H. B. ROBINSON UNIT 2

AMENDMENT TO FACILITY OPERATING LICENSE

Amendment No. 12
License No. DPR-23

CHANGE NO. 37 TO THE TECHNICAL SPECIFICATIONS

Figure 3.1-1

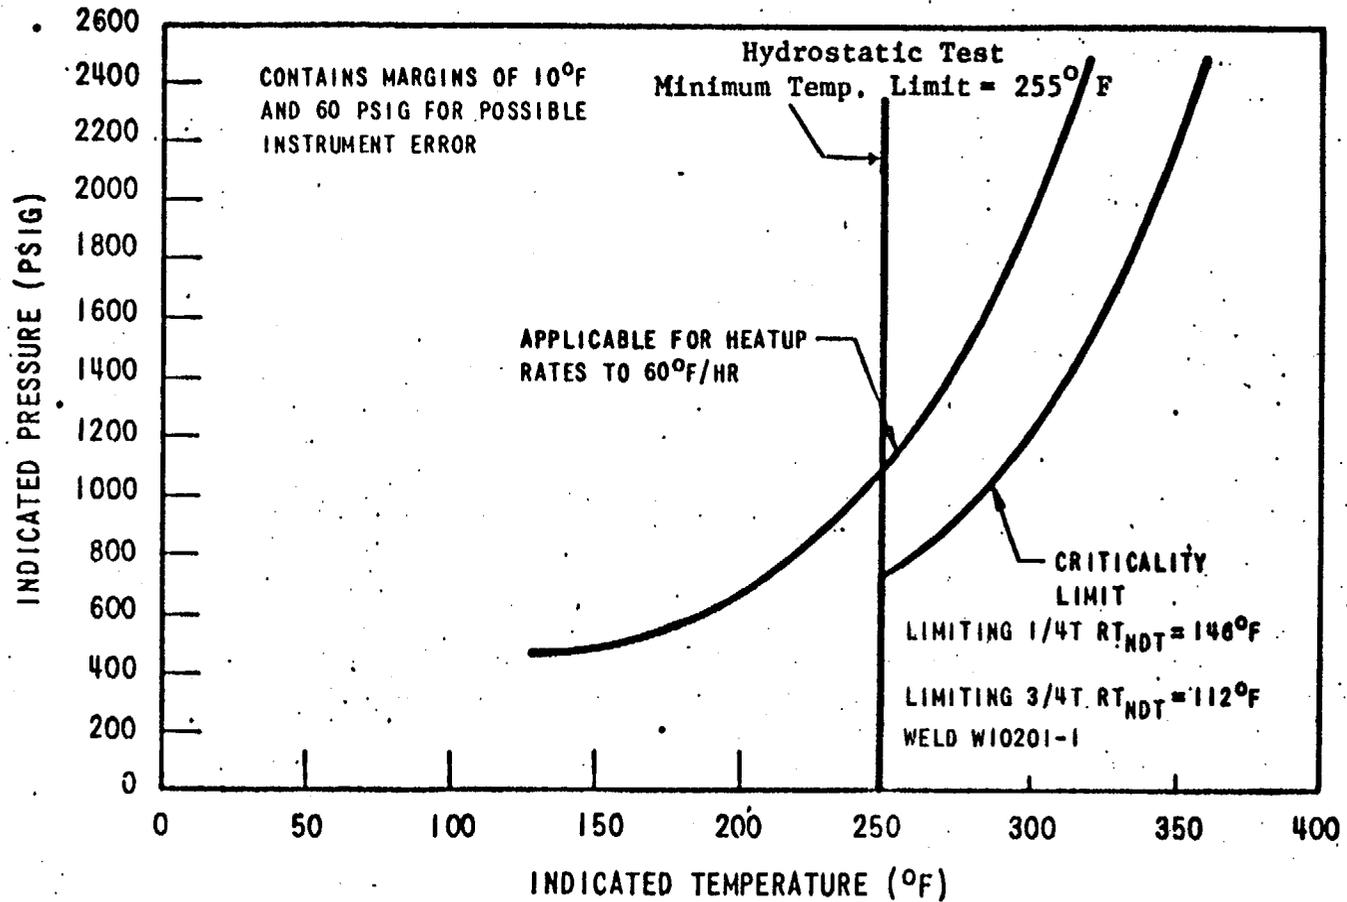
Replace Figures 3.1-1 and 3.1-2 with the attached revised Figures.

3.1.2.1 The reactor coolant pressure and the system heatup and cooldown rates (with the exception of the pressurizer) shall be limited in accordance with Figure 3.1-1 and Figure 3.1-2, and are as follows:

- a. Over the temperature range from cold shutdown to hot operating conditions, the heatup rate shall not exceed 60°F/hr in any one hour.
- b. Allowable combinations of pressure and temperature for a specific cooldown rate are below and to the right of the limit lines for that rate as shown on Figure 3.1-2. This rate shall not exceed 100°F/hr in any one hour. The limit lines for cooling rates between those shown in Figure 3.1-2 may be obtained by interpolation.
- c. Primary System Hydrostatic leak tests may be performed as necessary, provided the temperature limitation as noted on Figure 3.1-1 is not violated. Maximum hydrostatic test pressure should remain below 2350 psia.

Using the methods of ASME code Appendix G for determining stress intensity factors for the 1/4T assumed flaw, K_{Im} is 58.13 Ksi \sqrt{in} and thus, $1.5 K_{Im}$ is 87.2 Ksi \sqrt{in} . In order for K_{IR} to be 87.2 Ksi \sqrt{in} or greater, a temperature of $RT_{NDT} + 109^{\circ}F$ must be attained as determined from the K_{IR} curve of ASME Code Appendix G. This results in the limit shown on Figure 3.1-1 for the applicable integrated power period.

The heatup curve of Figure 3.1-1 includes criticality limits which are required by 10 CFR Part 50 Appendix G paragraph IV.A.2.c. Whenever the core is critical, additional safety margins above those specified by the ASME Code Appendix G methods, are imposed. The core may be critical at temperatures equal to or above the minimum temperature for the inservice hydrostatic pressure tests as calculated by ASME Code Appendix G methods, and an additional safety margin of 40°F must be maintained above the applicable heatup curve at all times. 37

H. B. Robinson Unit No. 2 Reactor Coolant System Heatup Limitations Applicable For the First 4.25 Effective Full Power Years (Fluence $\approx 3.7 \times 10^{18} \text{N/CM}^2$)
